*The Reno Creek ISR Project
Campbell County, Wyoming*

**Revised RAI Response Package:
Technical Report**

December 2014

10288 West Chatfield Ave., Suite 201
Littleton, Colorado 80127-4239 USA
303-290-9414
www.petrotek.com

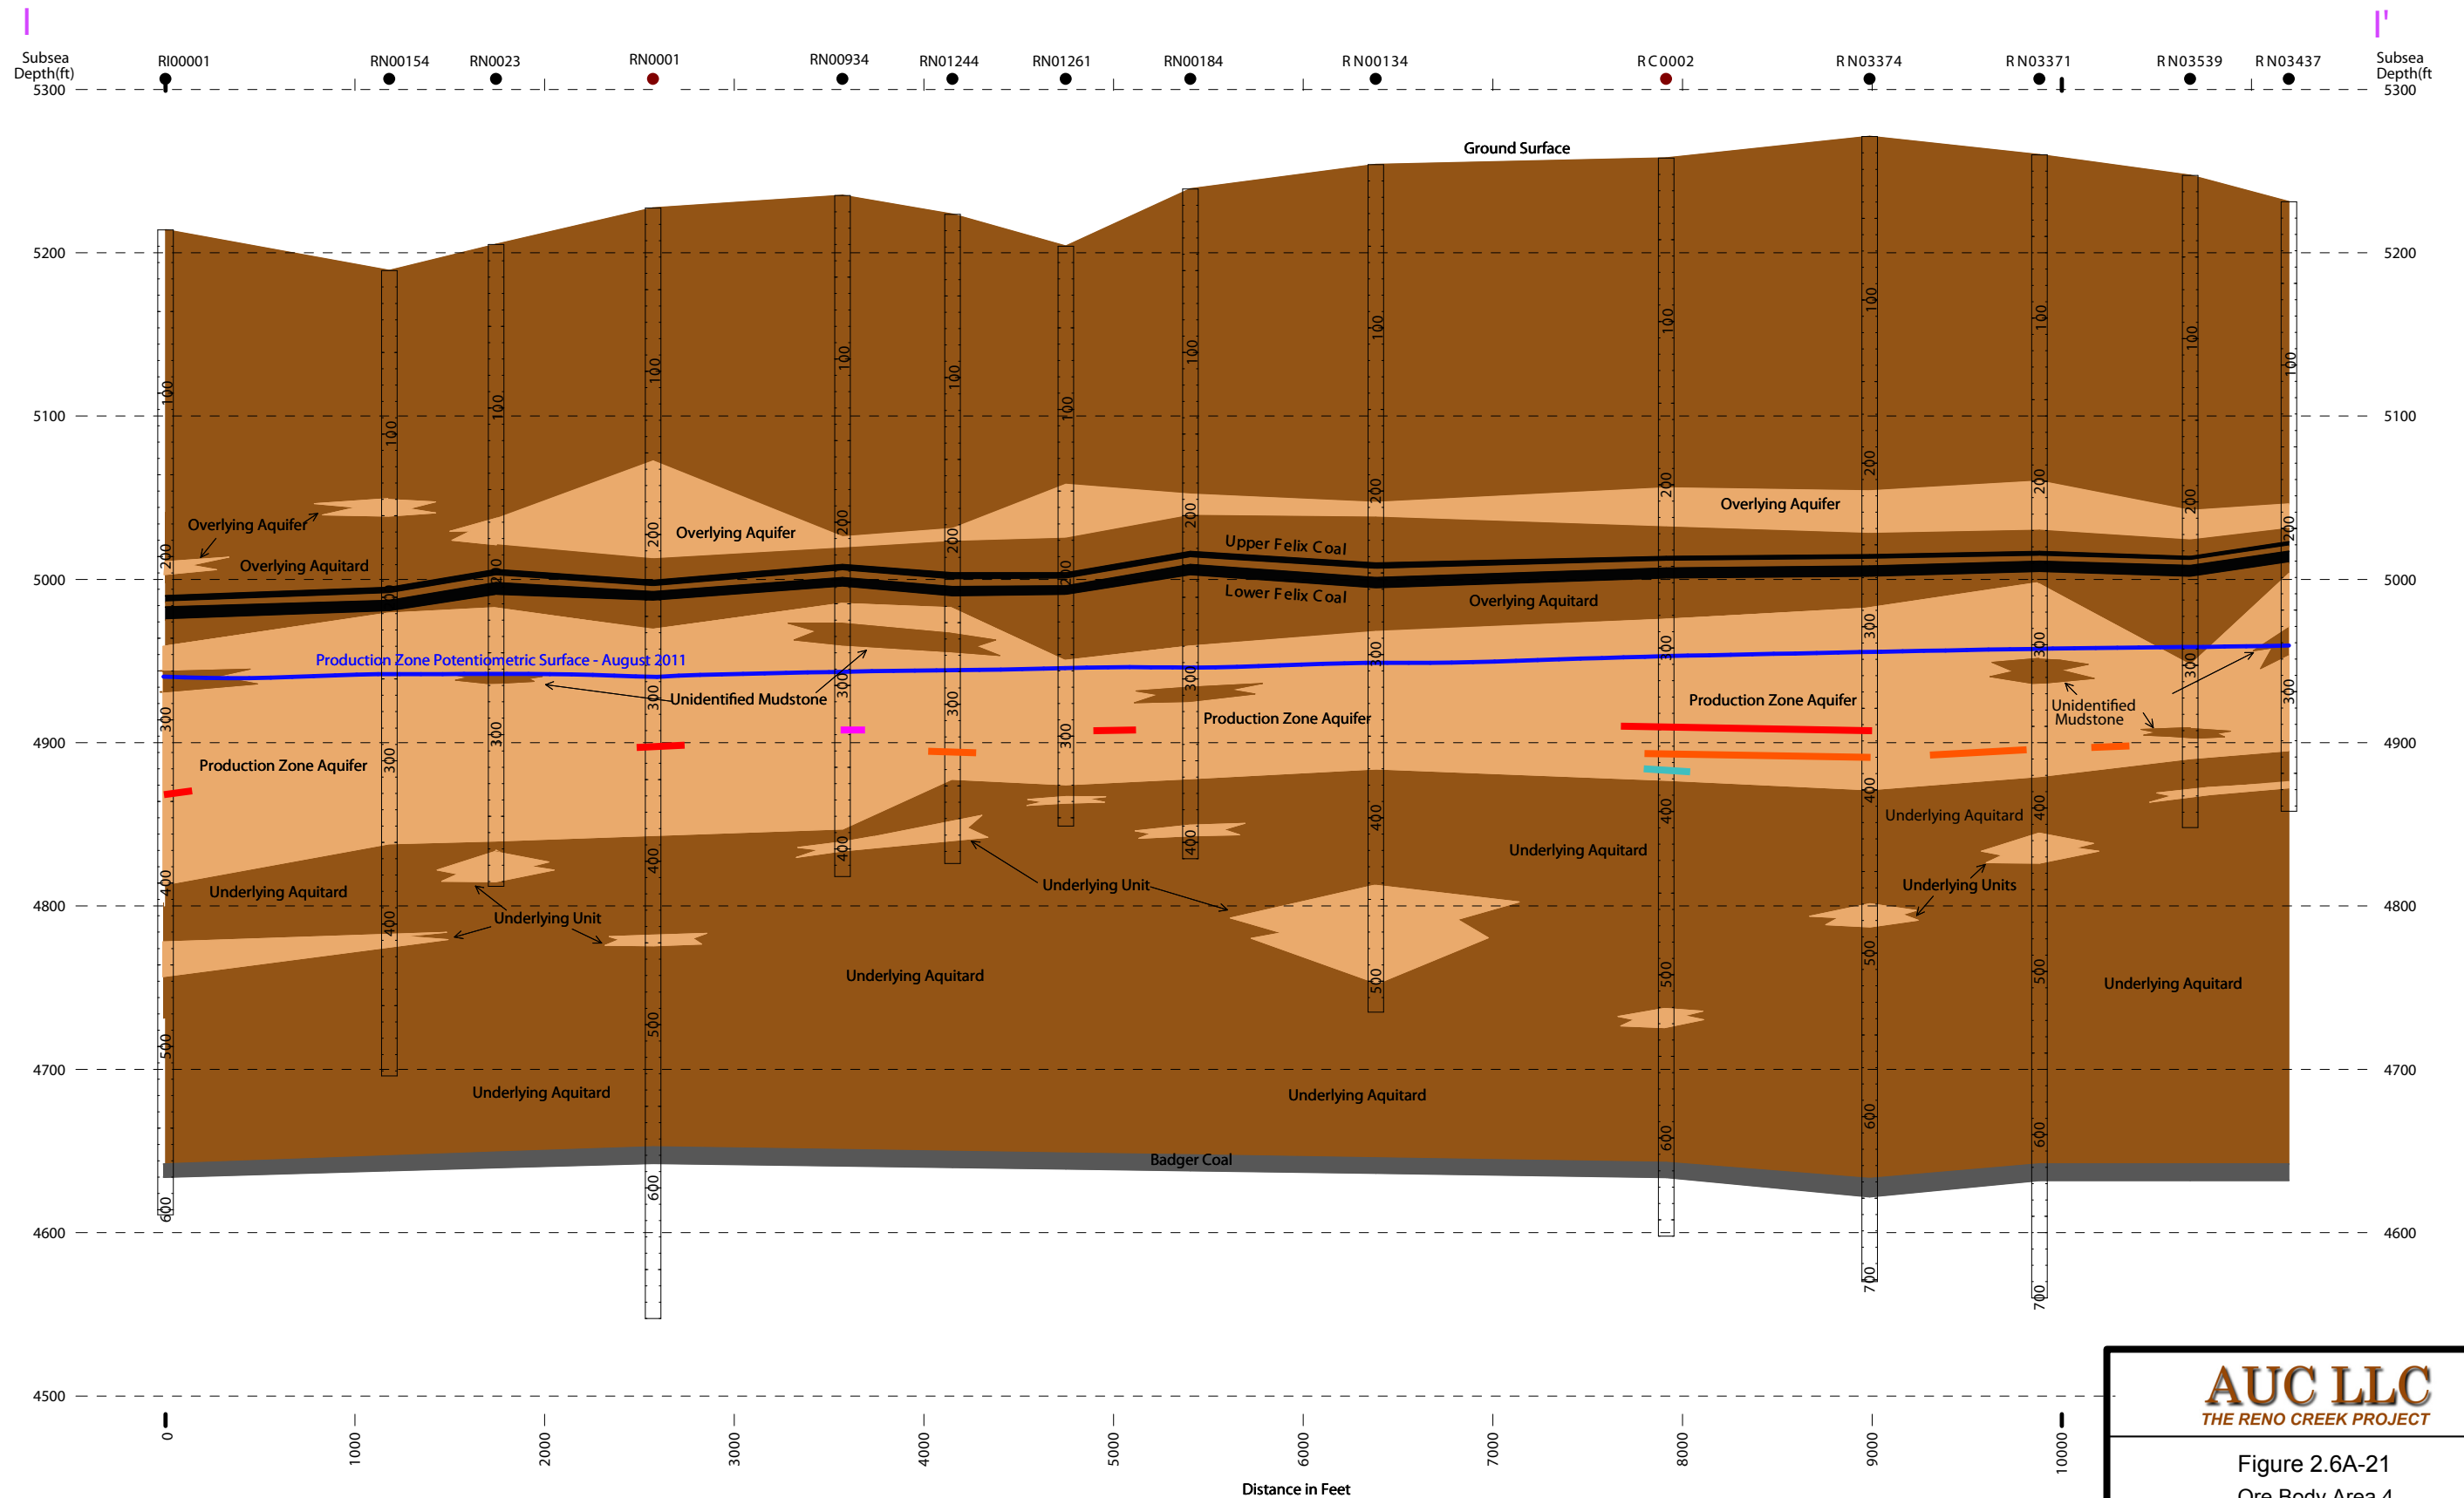
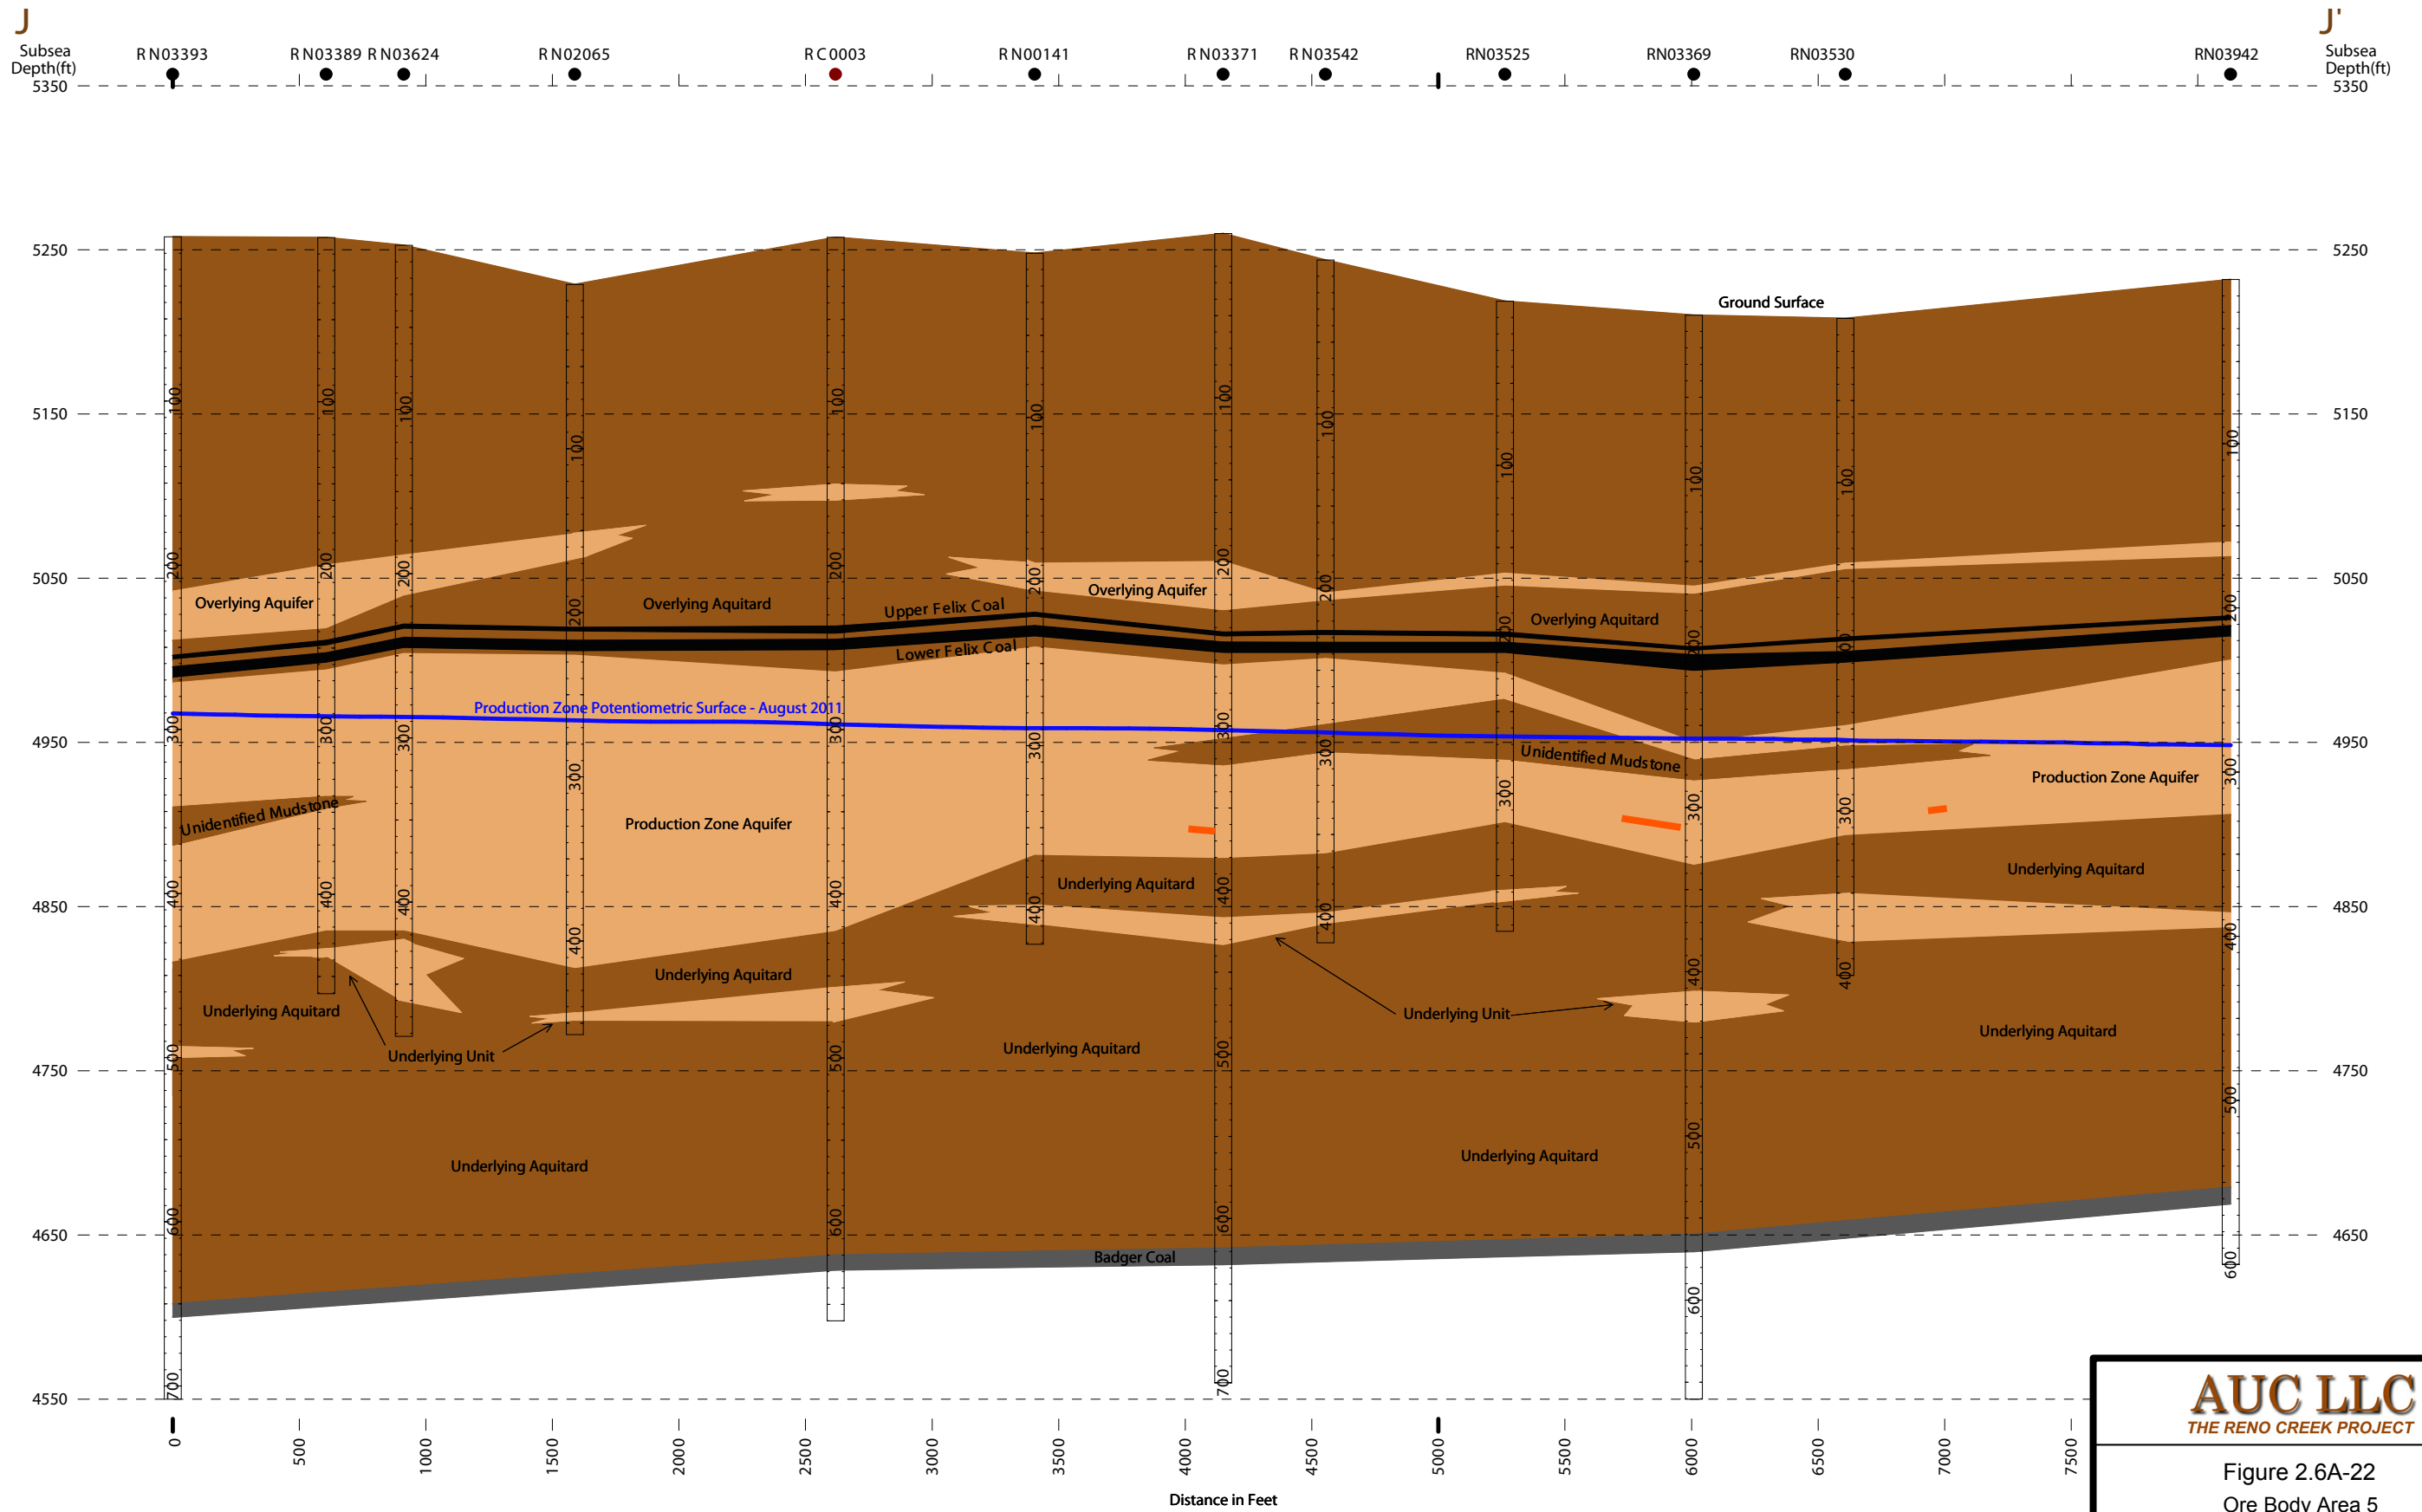
- a) Please provide mapping (including depicting the ore body on the cross-sections) that demonstrates the ore trends including the oxidation and reductions zones.*
- b) Please clarify whether or not Figure 2.6A-17 displays all ore-trend labels, including oxidation and reduction zones.*

On Figure 2.6A-27, the application presented a cross-sectional view of a typical roll front; however, the application did not include cross-sectional views of the ore body within the production zone aquifer throughout the project area (e.g., Figures 2.6A-18 through -23).

“At various localities within the Proposed Project area all horizons from the base to the top of the host sandstone (PZA) can be favorable for uranium deposition. However, economically significant uranium mineralization occurs most frequently in the lower half of the PZA. This relationship and **depiction of the ore trends, including oxidation/reduction boundaries is shown on Figure 2.6A-17. Cross sections depicting the vertical stacking of the ore trends are included as Figures 2.6A-18 through 2.6A-23.**”

Figure 2.6A-17 and Figures 2.6A-18 through 2.6A-23 are shown below:
